PLANNING AND ZONING BOARD STAFF REPORT

Fifth Third Bank

Meeting	File No.	Application Type
November 17, 2025	PZ-000014-2025 (Level 4 Site Plan) PZ-000015-2025 (Waiver)	Level 4 Site Plan Modification, with Waiver
Property Owner	Authorized Agent	
1820 Federal Delray LLC	Nisit Sapparkhao, Infinity Engineering Group LLC

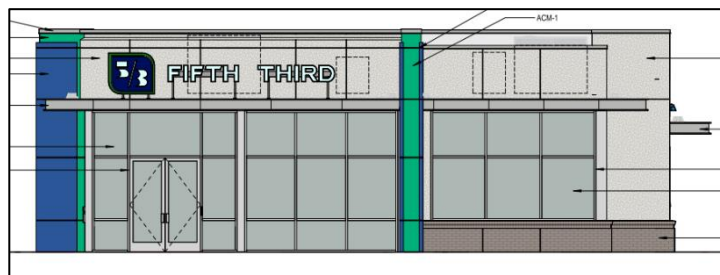
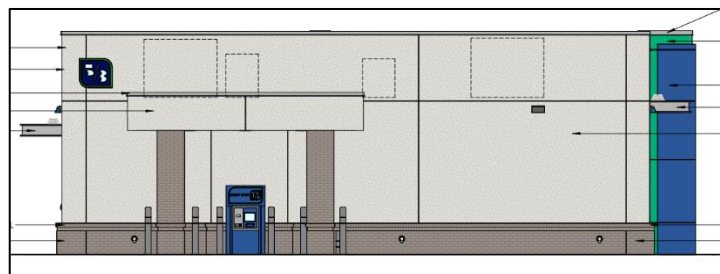
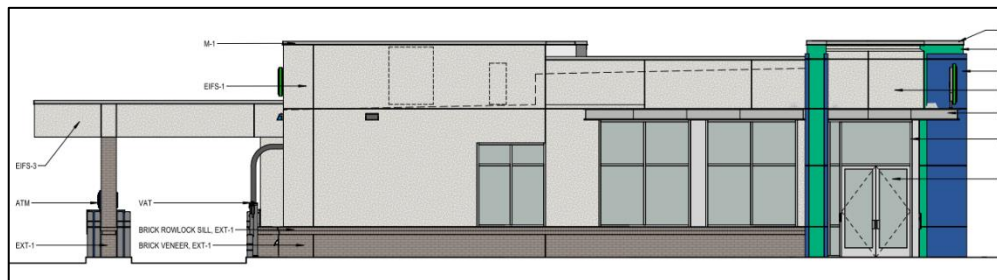
Staff has reviewed the architectural elevations and finds that the project meets the intent of Section 4.6.18 by integrating compatible materials, colors, and massing. The building utilizes brick veneer accent features, a light neutral Dover Sky finish, and the signature Fifth Third blue and green color scheme in a balanced and restrained manner. Overall, the proposed architecture is appropriate to its setting, complements surrounding structures, and contributes to a unified visual character along the corridor.

The height of the building includes a parapet that ranges from one foot to five feet and 11 inches to effectively screen the roof equipment. The parapet exceeds the maximum allowed height of 4 feet pursuant to LDR Table 4.3.4(J)(3) by one foot and 11 inches. The requested height exception for the parapet does not exceed the maximum allowed height of 48 feet within the PC zoning district, however. Pursuant to LDR Table 4.3.4(J)(3), parapets between four to 10 feet are an exception to the maximum height and the height exception requires board action by the approving body. The architectural elevations demonstrate the necessity of the parapet for screening purposes and its integration into the overall building design. A justification statement has been provided by the applicant addressing compliance with the criteria of Section 4.6.18(E). The Board must determine whether the height exception maintains the intent of the regulation, preserves the visual quality of the surrounding area, and does not result in adverse impacts on the local environment.
